PUBLIC INTEREST REVIEW FOR GROUNDWATER APPLICATIONS

TO: Water Rights Section Date 4/24/2020  
 FROM: Groundwater Section Jen Woody Reviewer's Name  
 SUBJECT: Application G- 18690 Supersedes review of 1/23/2019 Date of Review(s)

**A. GENERAL INFORMATION:** Applicant's Name: C & E Brentano Family LP County: Marion

**Figure 3. Stream depletion POAs 5 and 6, Mission and Champoeg Creeks, using conservatively long pumping duration. Stream depletion estimates are smaller than the margin of error associated with aquifer parameter estimation, so PSI is not triggered per Section C4a.**

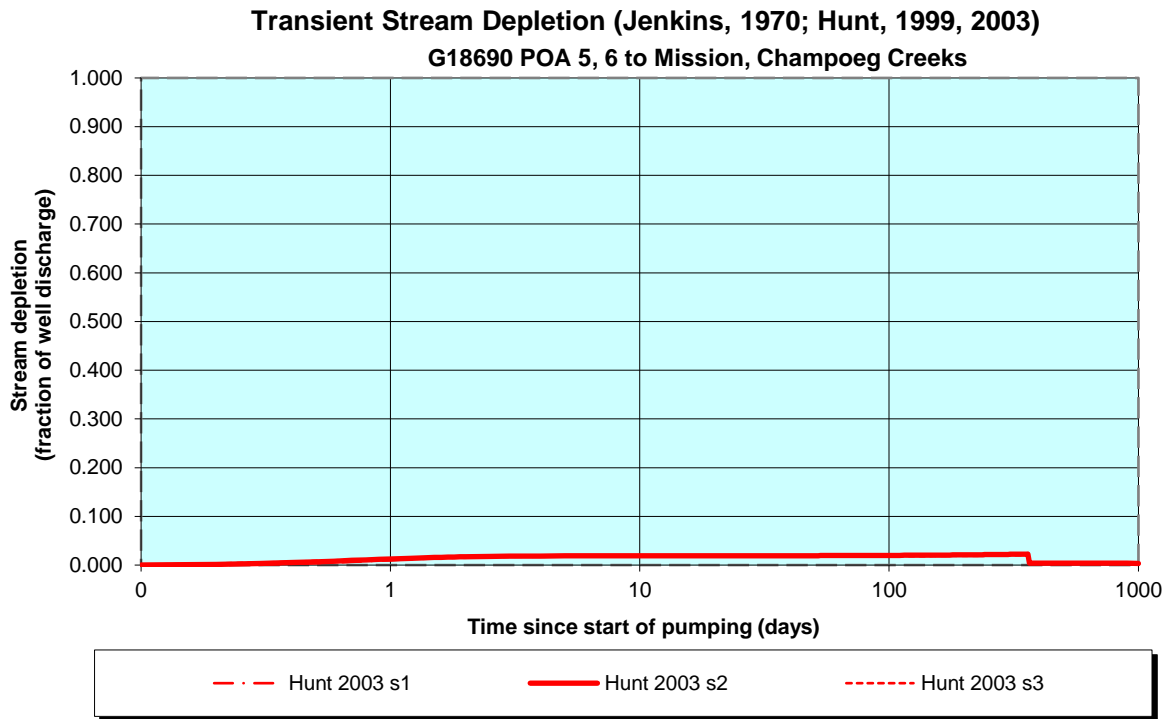
While the proposed wells will be hydraulically connected to Mission and Champoeg Creeks, stream depletion estimates are small enough to be within the margin of error associated with aquifer parameters. Therefore Section C4a does not trigger PSI.

Figure 4. Water-Level Trends in Nearby Wells

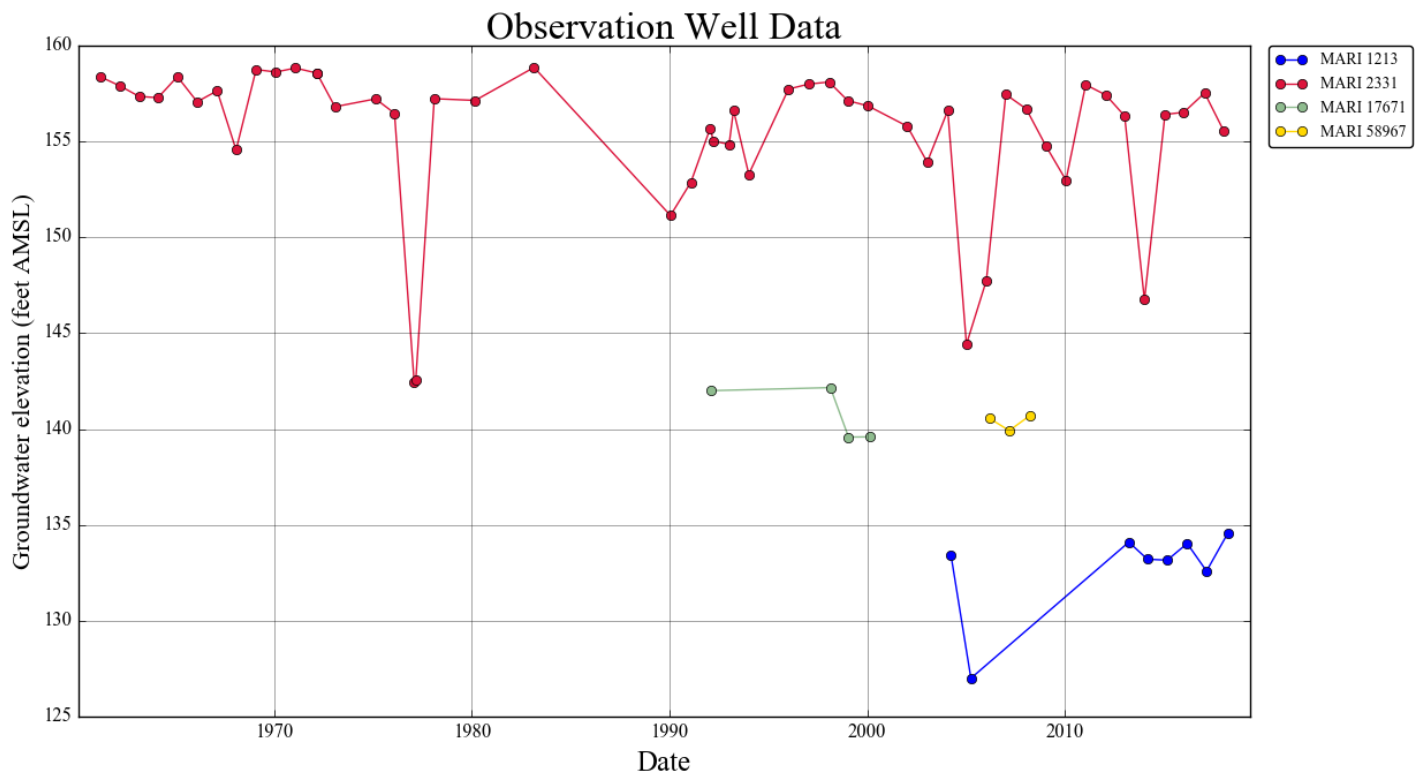
Water level data from state observation well MARI 2331 indicates seasonal fluctuations of about 20 feet, but relatively stable conditions over the last 50 years (see hydrograph in Fig. 3). The thin, lenticular geometry of the water-bearing zones and the large proposed rate indicate that water-use reporting and water-level measurement conditions are recommended to protect other users.

Figure 5. Distance-drawdown estimates for POA 10 to POA 1 on Permit G-17955 indicate the potential for injury to nearby wells. This estimate uses the highest proposed rate: 1657 gpm nursery use from Nov 1- Feb 28/29.

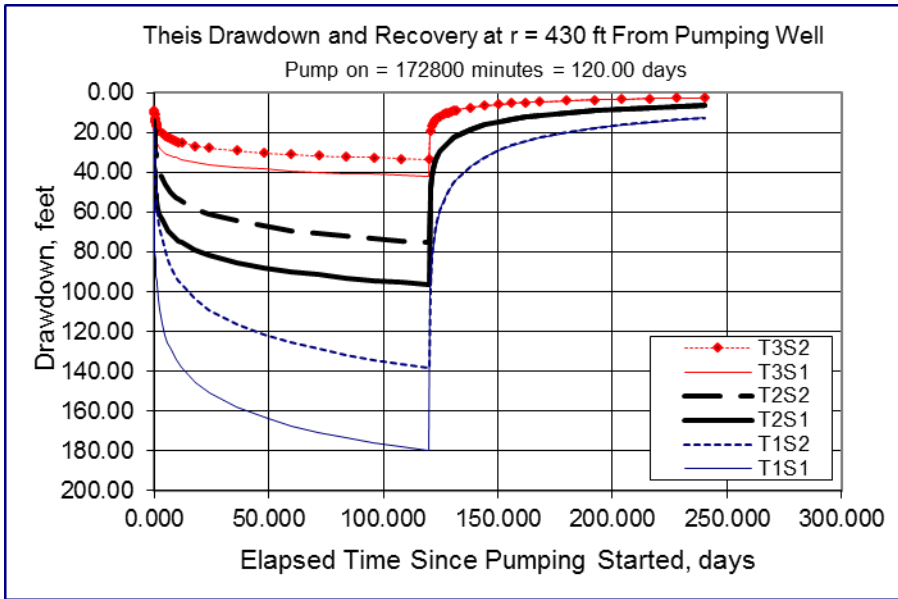
Proposed POA 10 is located approximately 400 feet from POA 1 associated with Permit G-17955. Additionally, there is a house located 500 feet from POA 10 that likely has an exempt well. Figure 5 shows there is potential for significant drawdown interference (~25-150 feet at 120 days of pumping) at POA 1 if POA 10 is installed at the proposed location. B1b is checked for this reason. The proposed location for POA 9 does not trigger this finding. If POA 10 is removed from this application, the injury finding in section B1b will be avoided.
